Item 4.2 - Traffic - 23/11/18

SUBJECT: (4.2) Bannerman Street and Murdoch Street, Roundabout Amendments

AUTHOR: Report of Sustainable Transport Projects Coordinator, Lindsay Menday

Client and Job
 NORTH SYDNEY COUNCIL
 ROUTE 3 CYCLEWAY & STREETSCAPE IMPROVEMENT PLAN
 BANNERMAN STREET & MURDOCH STREET, NEUTRAL BAY

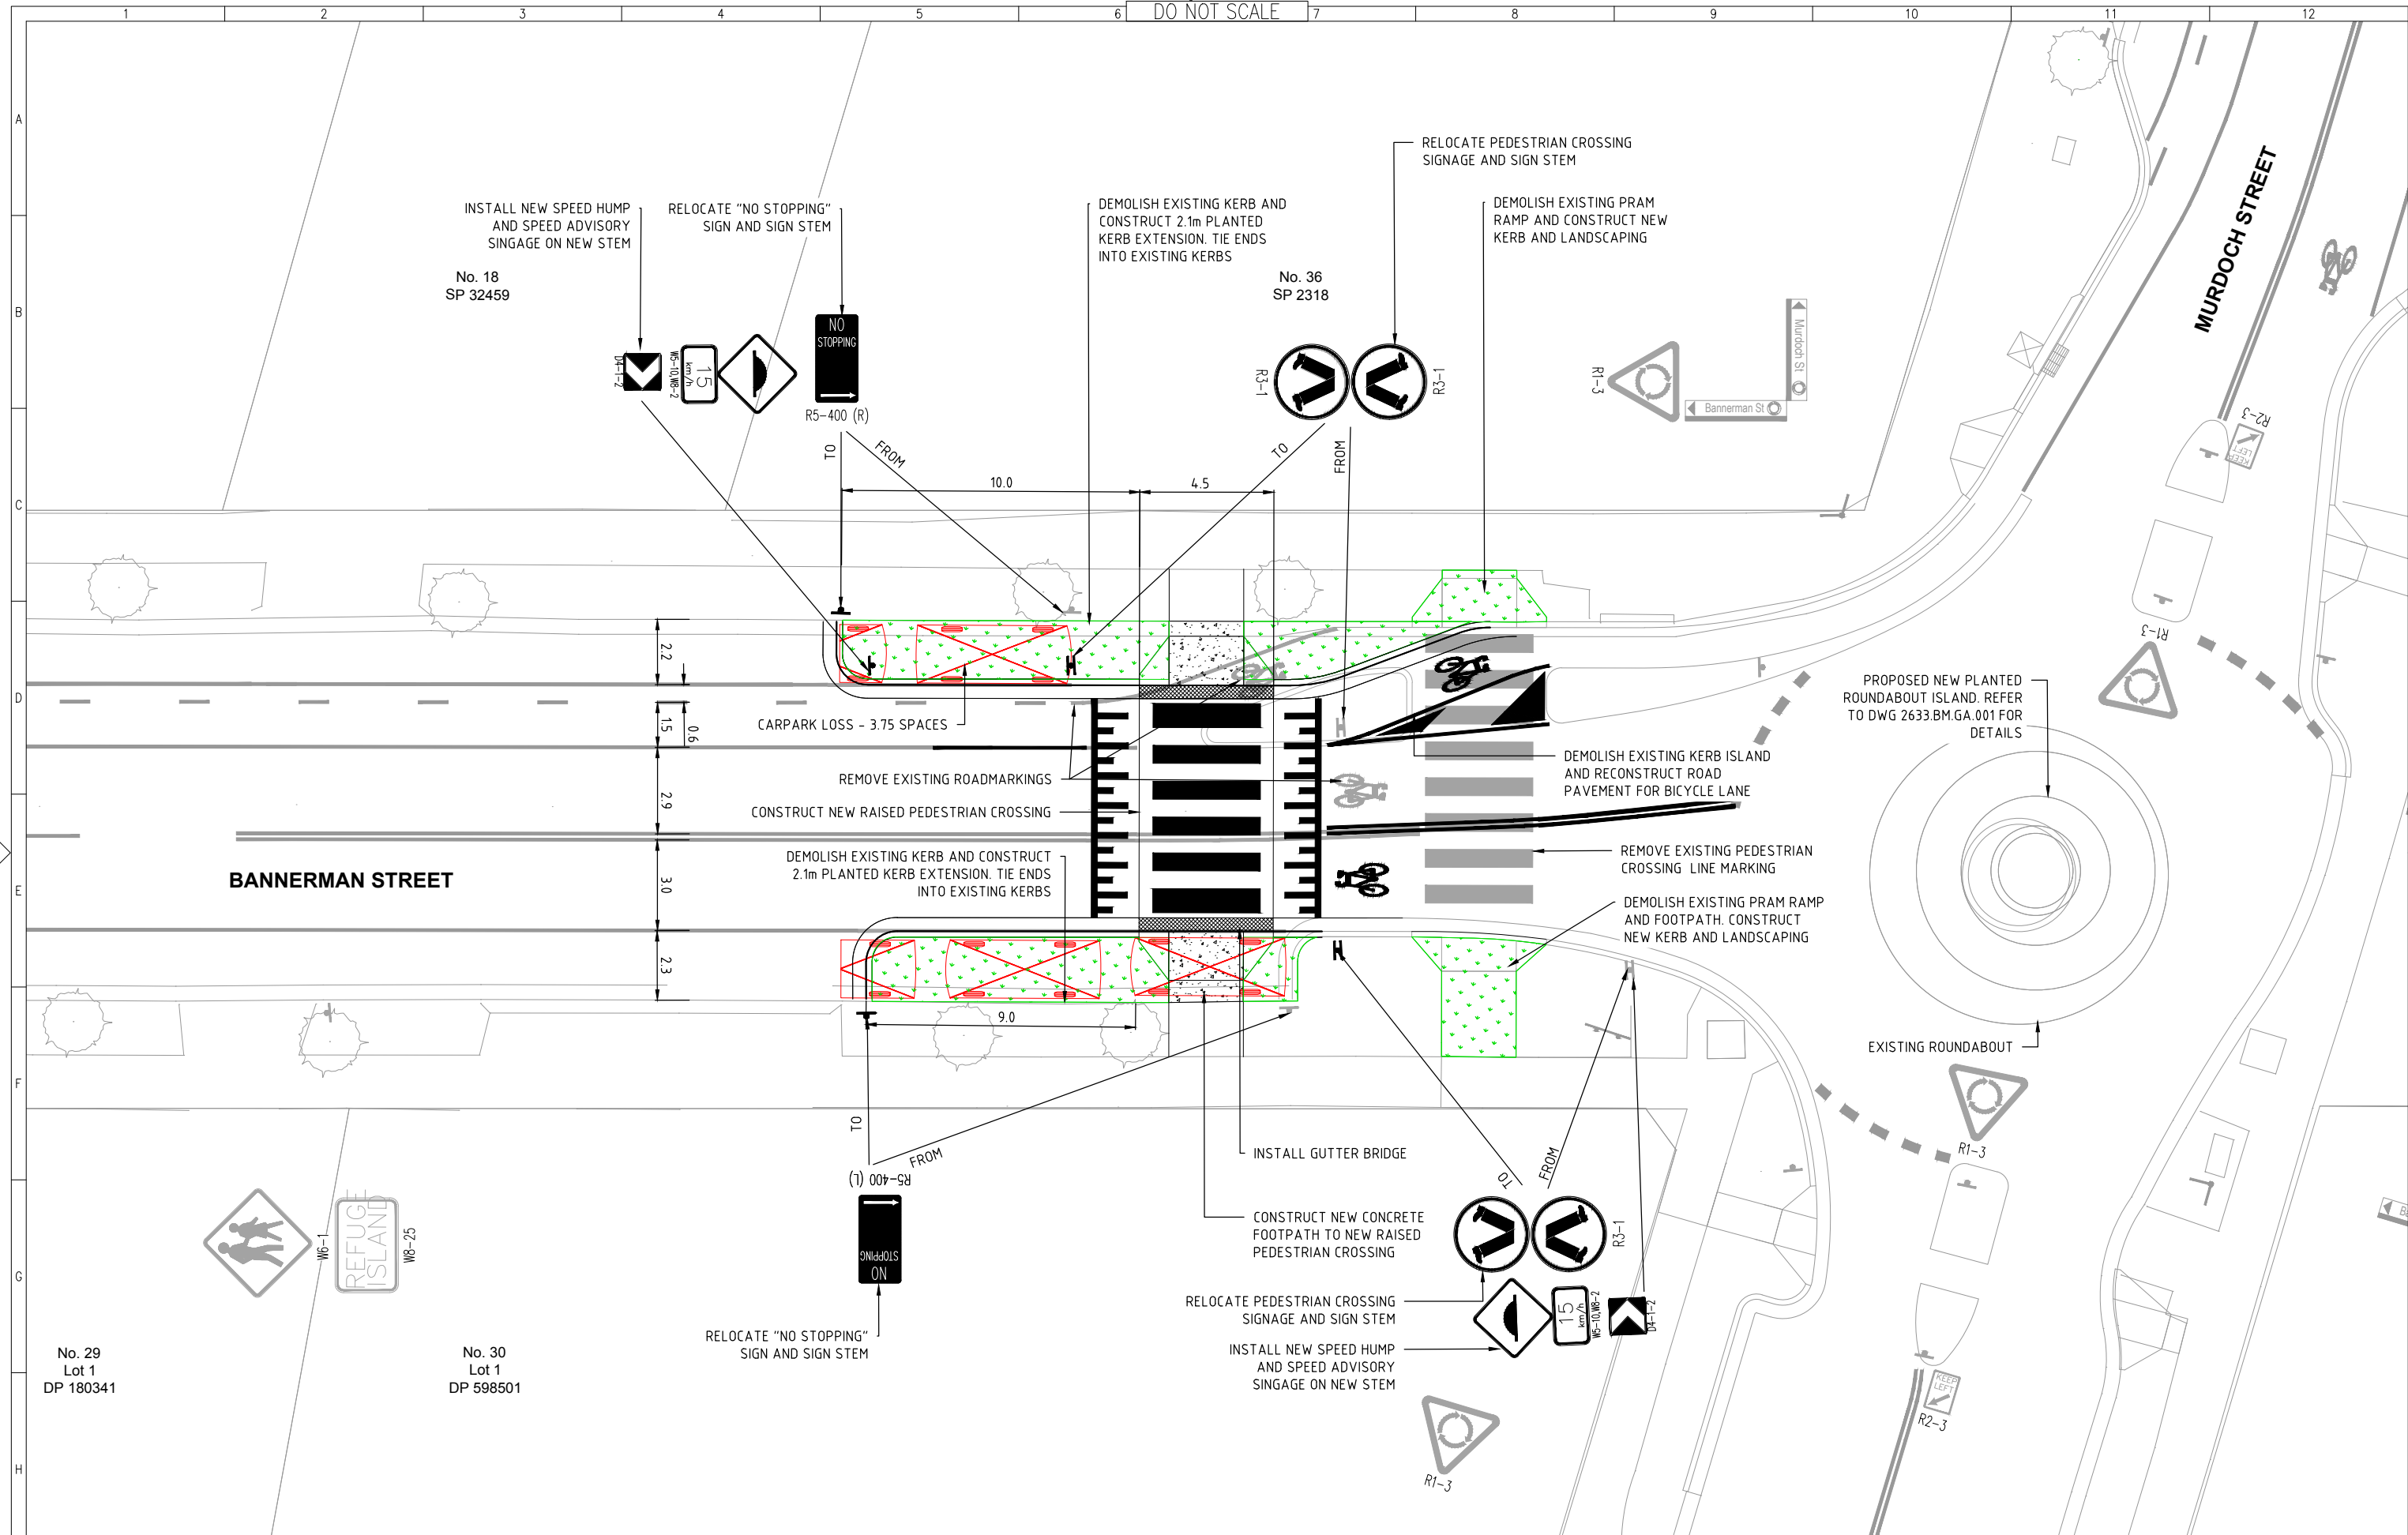
Attached to this report is a proposed design for the roundabout in accordance with the resolution. The amendments proposed to the roundabout comprise:

- A reduction in the size of the central circle from 10m to 8m diameter. The proposed diameter corresponds with the size of the circle that existed prior to the recent works.
- A central landscaping area to accommodate a new tree. The species proposed (“crepe myrtle”) is in accordance with Council’s tree planting strategy and is appropriate in terms of road safety requirements.
- A new paved internal circle to further improve visual amenity.

The proposed changes to the roundabout circle will increase the ease of vehicle manoeuvrability through the intersection.

Title
**CONCEPT DESIGN PLAN - BANNERMAN ST & MURDOCH ST
 ALTERNATIVE CROSSING LOCATION**

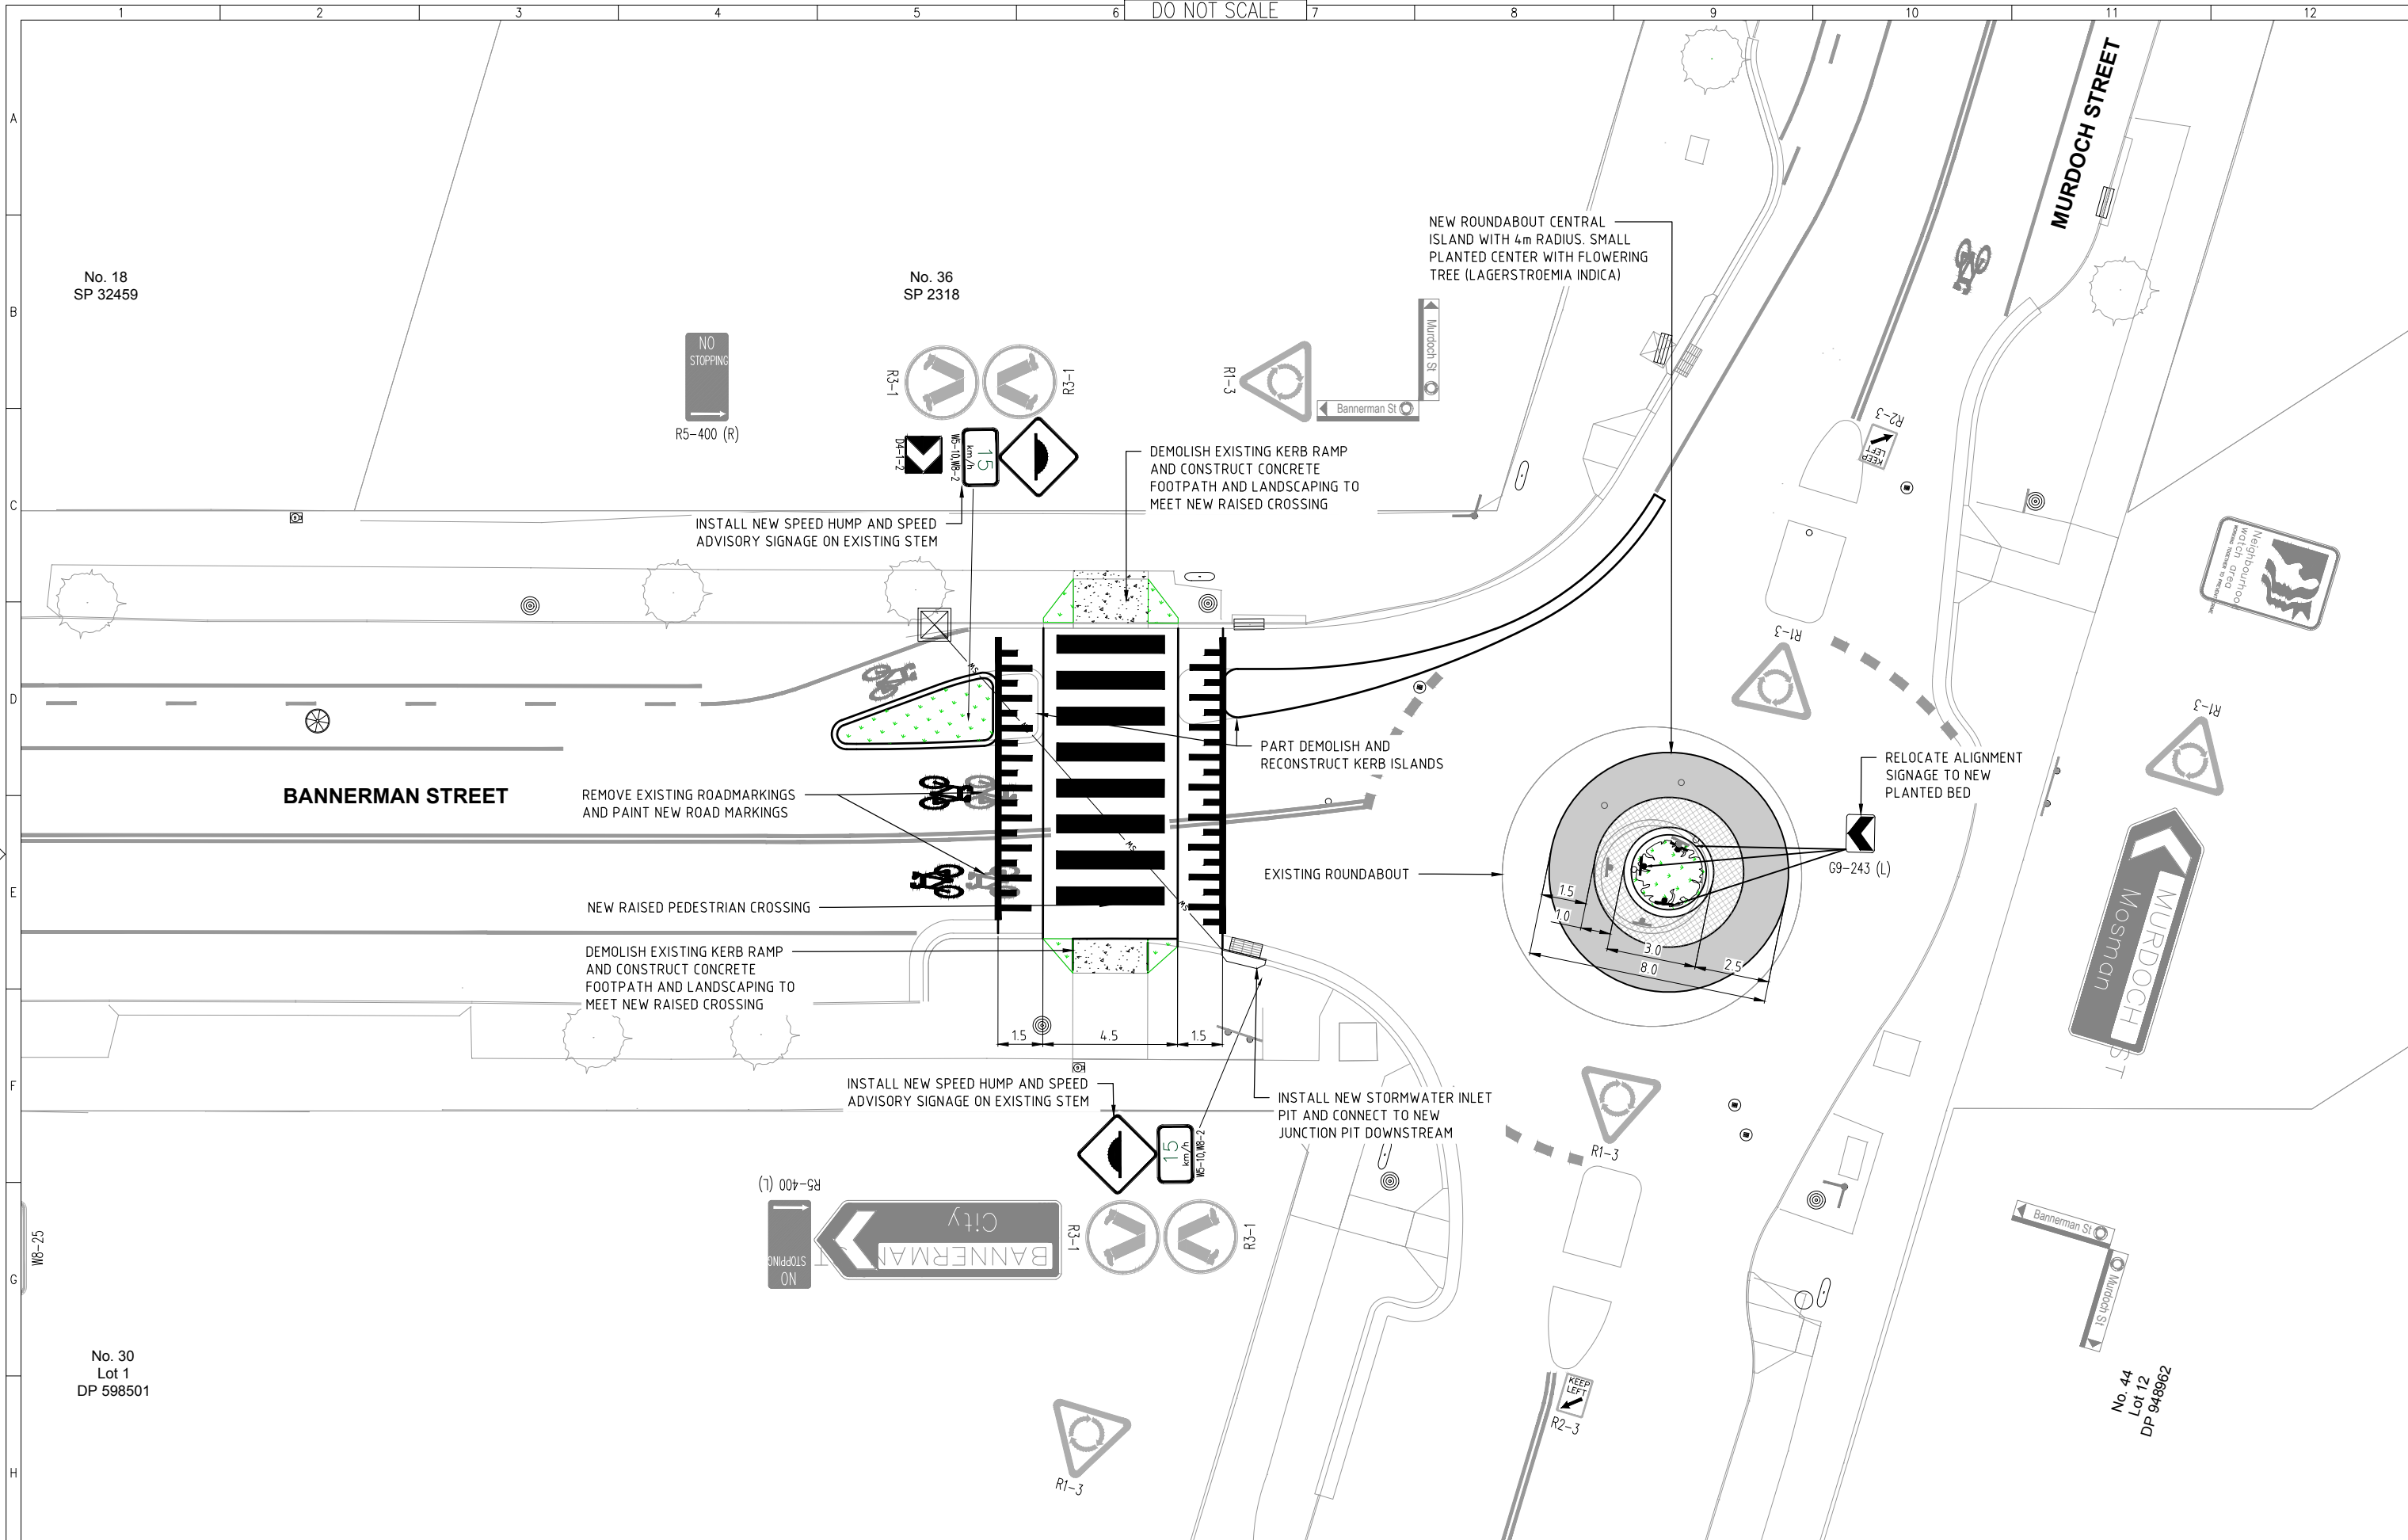
The plans also show a potential alternative location for a pedestrian crossing (Drawing 2633.BM.PC.001). The alternative location would require the removal of four (4) car parking spaces and increase the walking distance for those walking along Murdoch Street by about 60 metres, likely reducing the effectiveness of the pedestrian crossing. It is probable that if the crossing was relocated to this location that some pedestrians will cross at the intersection where there is no formal provision for people walking, instead of detouring to cross at a pedestrian crossing. In this context, it is recommended to retain the existing crossing location.
